Corrective Action Investigation Plan
for Corrective Action Unit 261:
Test Cell A Leachfield System,
Nevada Test Site, Nevada

RECORD OF TECHNICAL CHANGE

Technical Change No. 1

Project/Job Name Industrial Sites / CAU 261

Figure 1-2
CAU 261, Area 25, Test Cell A Leachfield

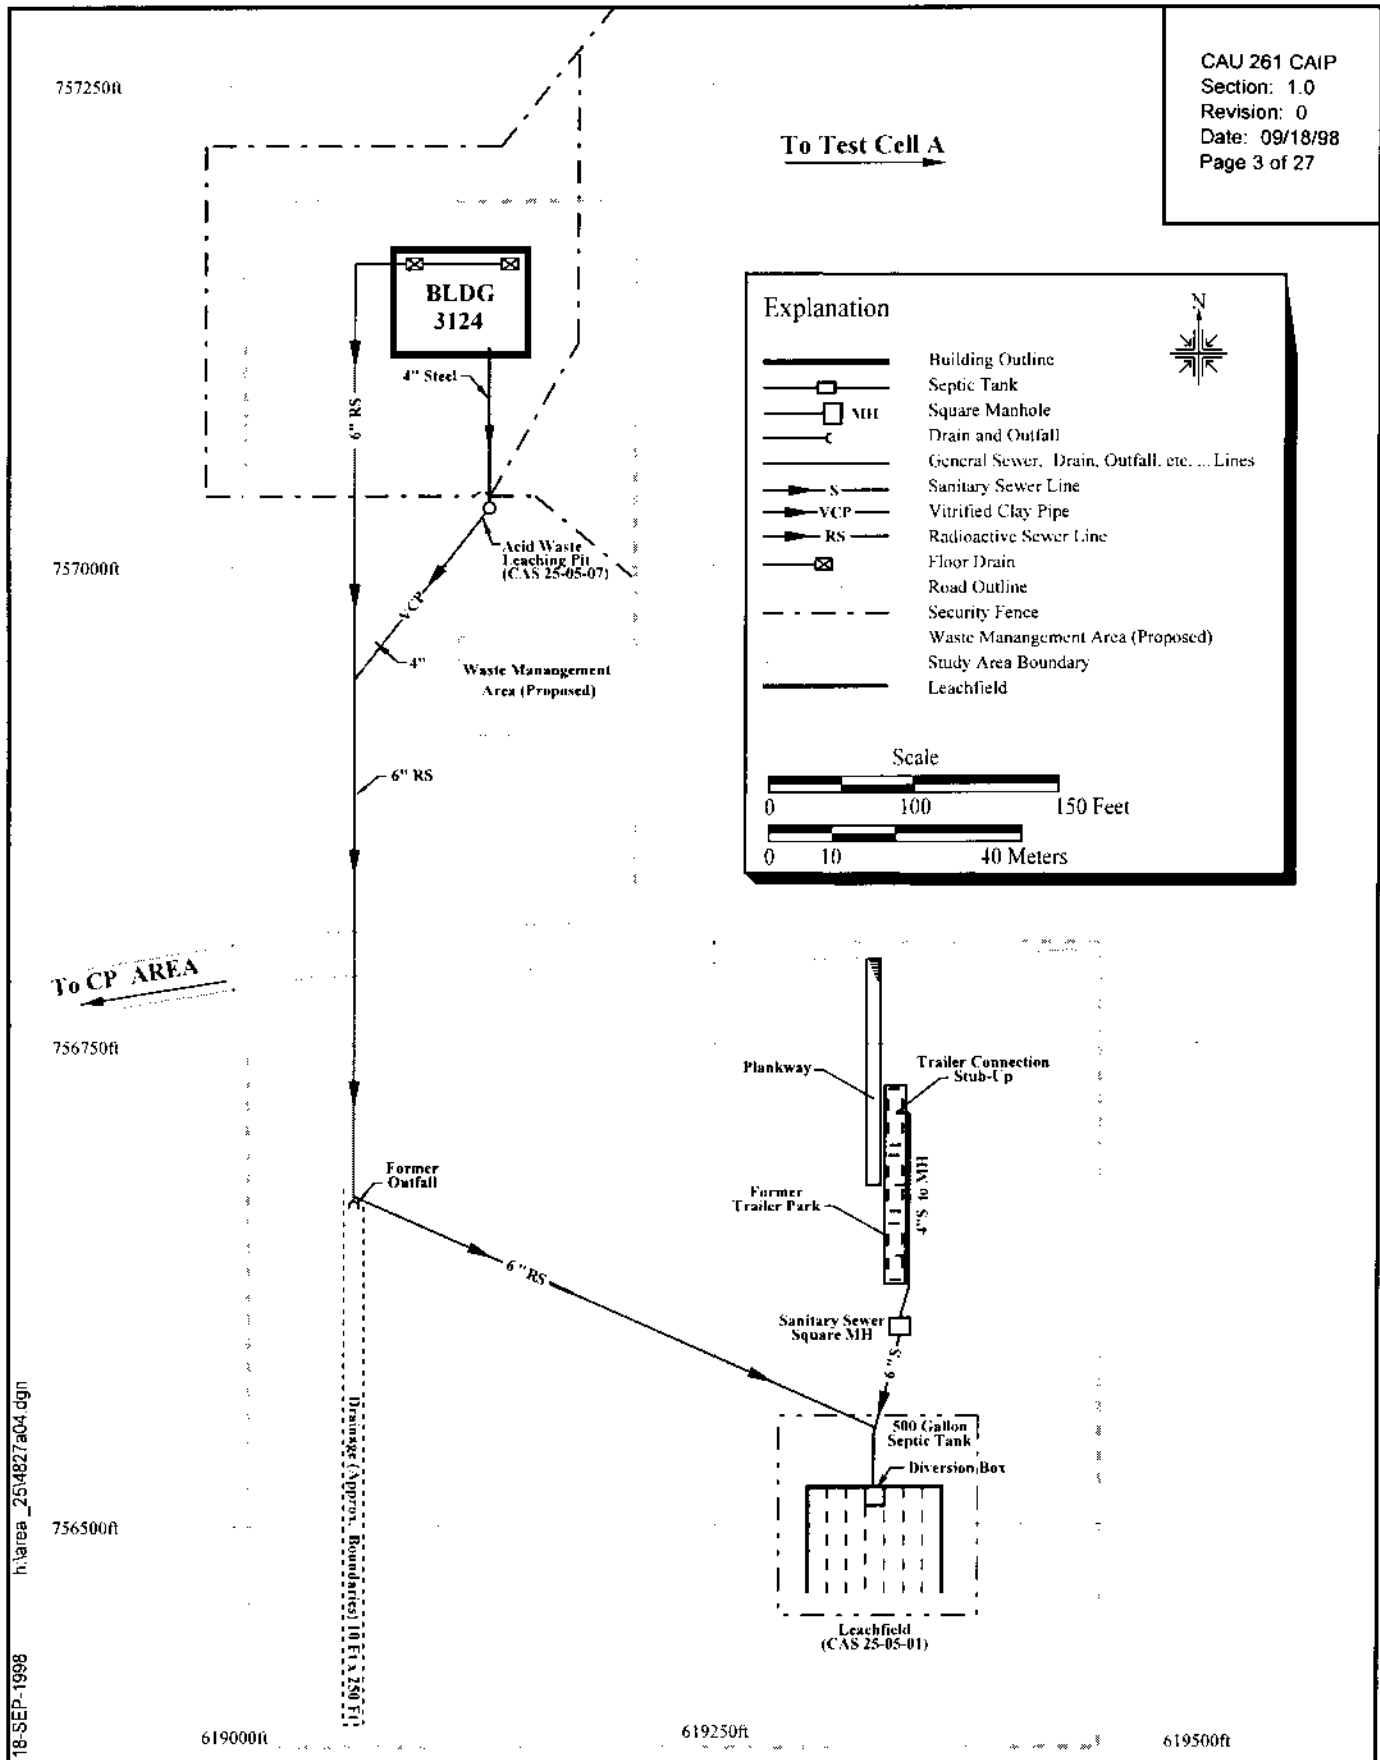
Figures 1-2, 4-1, and 4-2

Change 100 on foot scale to read 75.

10. Comment Number/ Location	11. Type ^a	12. Comment	13. Comment Response	14. Accept
1. Page ES-1, 1 st para.		The designation for CAS 25-05-01 as "Leachfield" as such is not on Figure 1-2: there is a "Radioactive Leachfield" which probably is the CAS. This must be clarified, both in the text and on the map by labeling the CASs with their respective numbers. Reference Figure 1-2 at this point in the text so the reader may identify the locations of the CASs at the time they are reading about them. Also, clarify if the leachfield contains radioactive contaminants. If it does, a new approach may have to be taken.	Comment accepted. The figure has been modified to reflect the CAS title as it is listed in the FFAO. The reference was added. The leachfield is fenced and posted as a radiological controlled area. A radioactive sewer line is shown in as-built drawings running from Building 3124 to this leachfield. The DQO centered around the possibility of radioactive contaminants. For this reason, drilling was chosen over trenching to investigate the site. The text was modified to clarify this point.	Yes
